AMENDMENT TO THE ASSESSMENT REPORT

For the Environmental Impact Statement for the IWS Northern Balefill

May 2005

Minister for Urban
Development and Planning

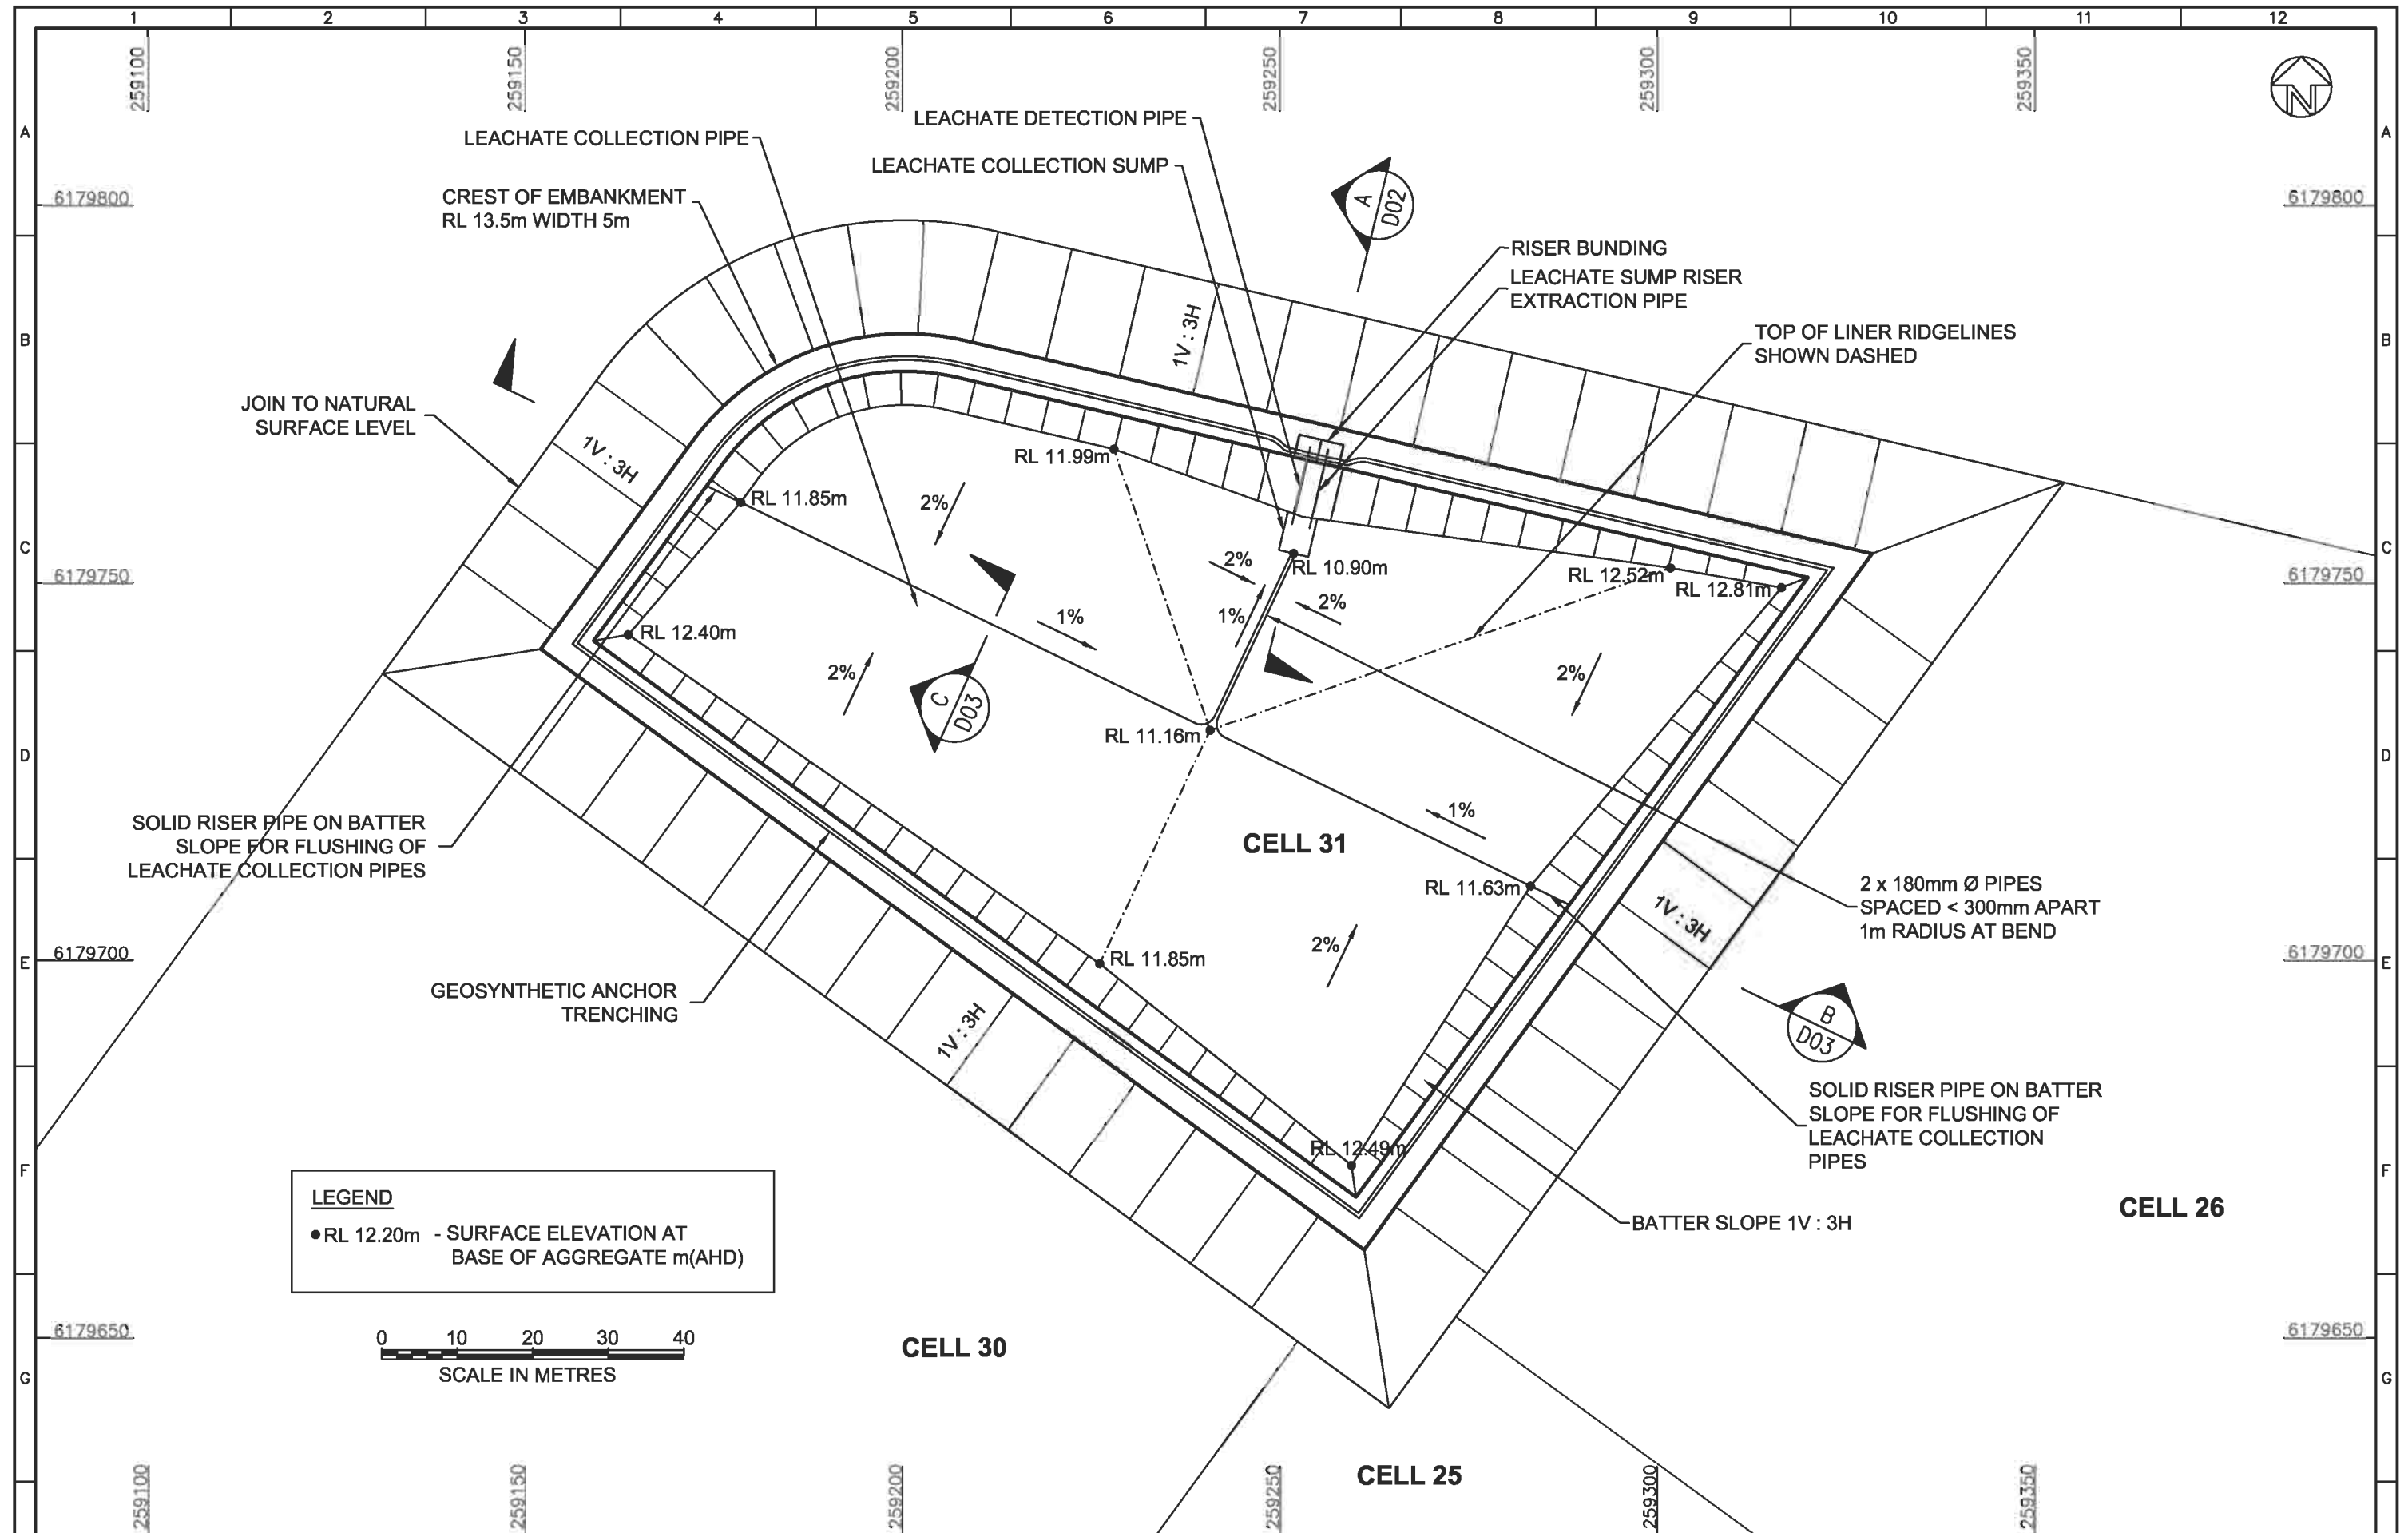
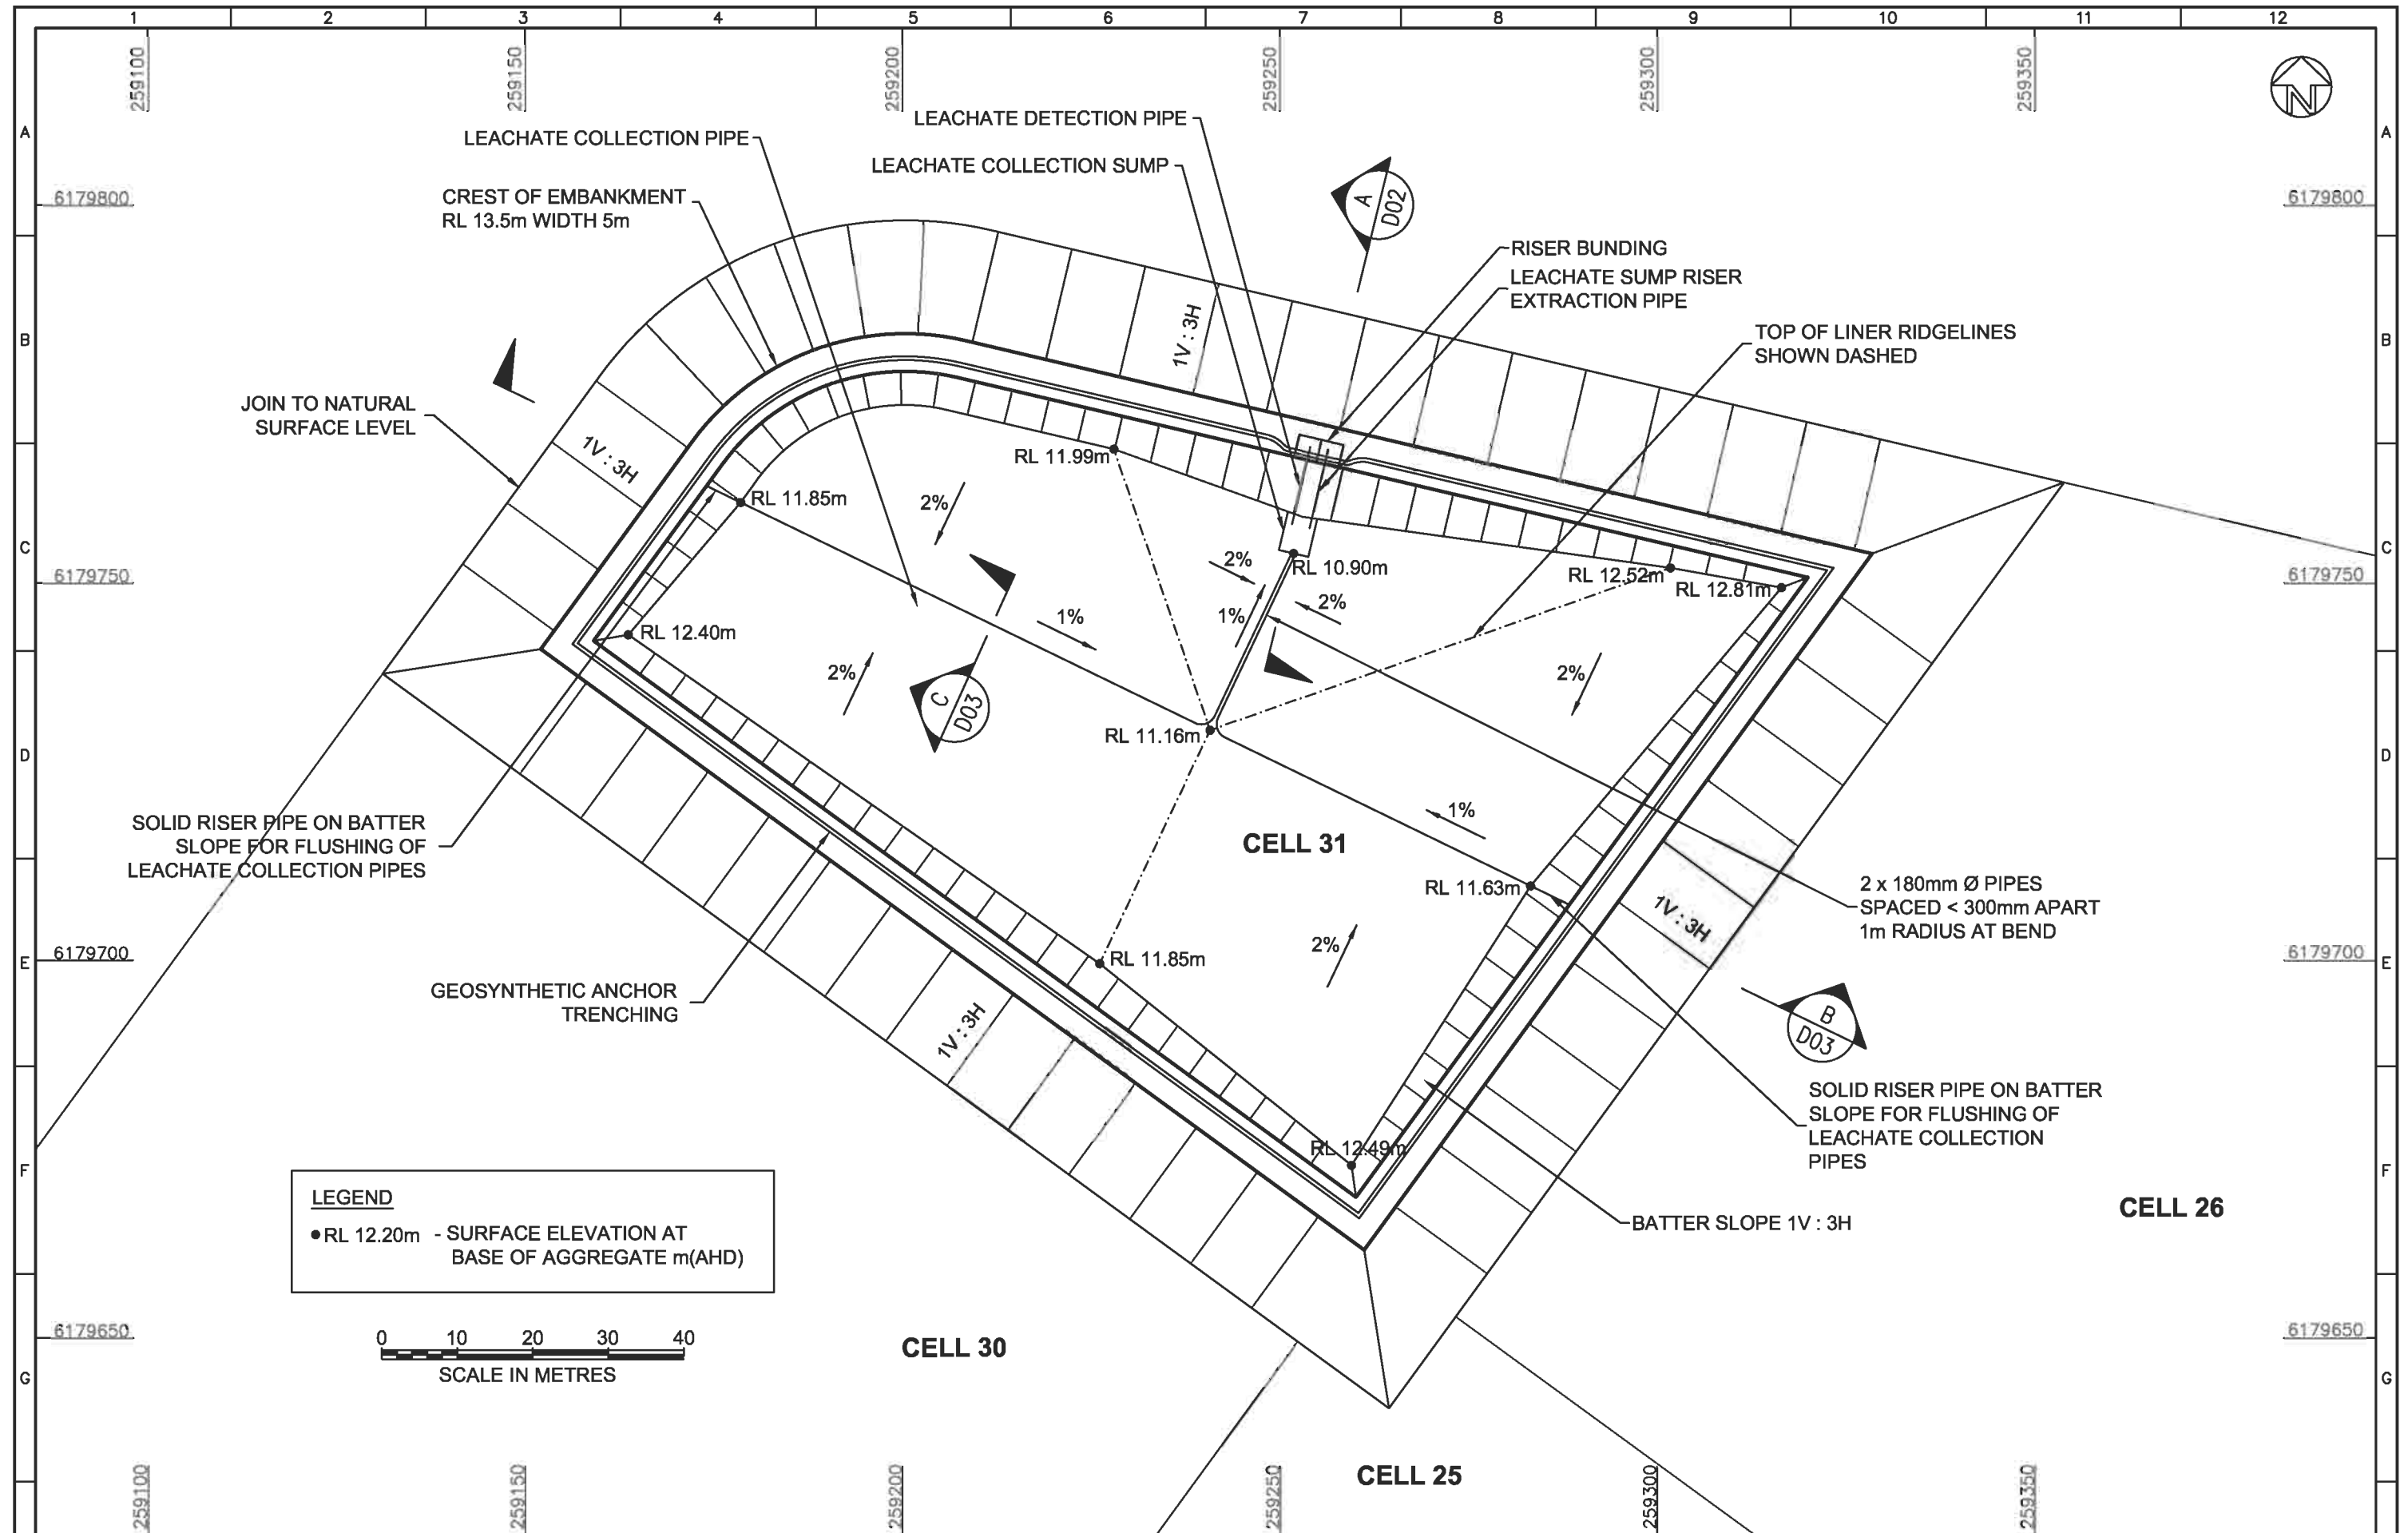
3. Leachate collection and extraction system:
 - Both leachate collection pipes shall:
 - o have a minimum diameter of 180mm (reference drawing 3307D01) with a 1m radius bend

CONCEPT PLAN ON CELL 31

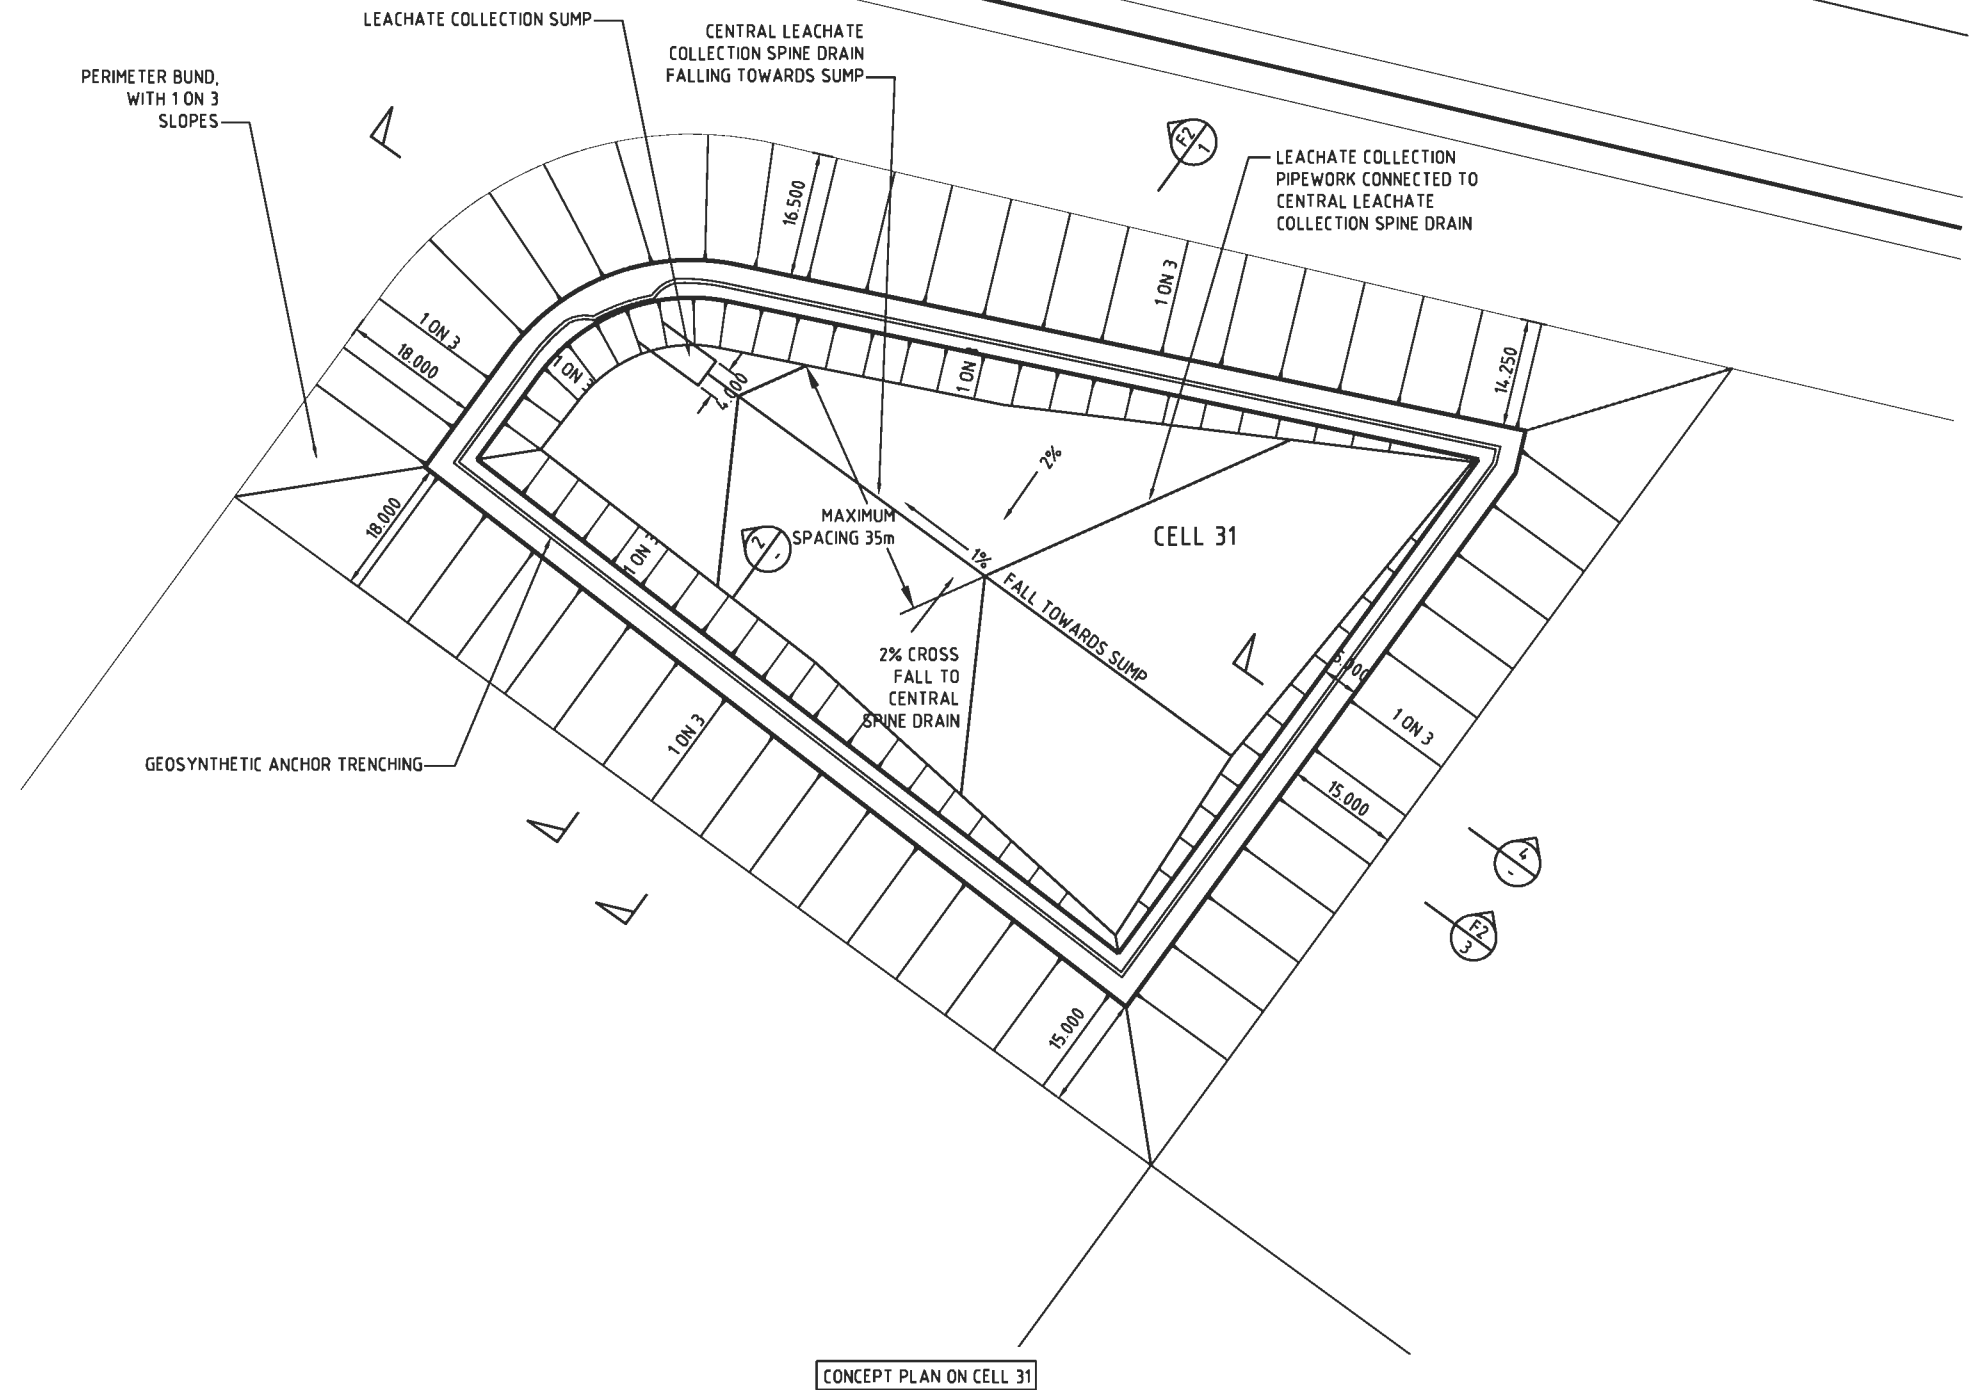
(p) Comment: Leachate drainage material: Drawing 210225a-COI indicates a drainage gravel blanket of '100mm Max'. The EPA specification for leachate collection blankets applies and it is recommended that this figure is amended in the relevant drawing.

(q) Comment: Geocomposite drainage system: Drawing 210225a-COI indicates that the geo-composite drainage system (GDS) would not cover the full base of Cell 31. It is recommended that the GDS is extended over the full base of Cell 31 and into the side lining system to the upper level of the leachate drainage blanket.

(s) Comment: Drawing 210225a-CO1: Clarification of the following is requested:

The thickness of the drainage blanket on Figure 1, Appendix H is 300mm. Current agreed gravel used in the drainage blanket for the balefill cells is proposed for this drainage blanket.

Response: This drawing has been redrafted, and is now Figure 1, Appendix H.
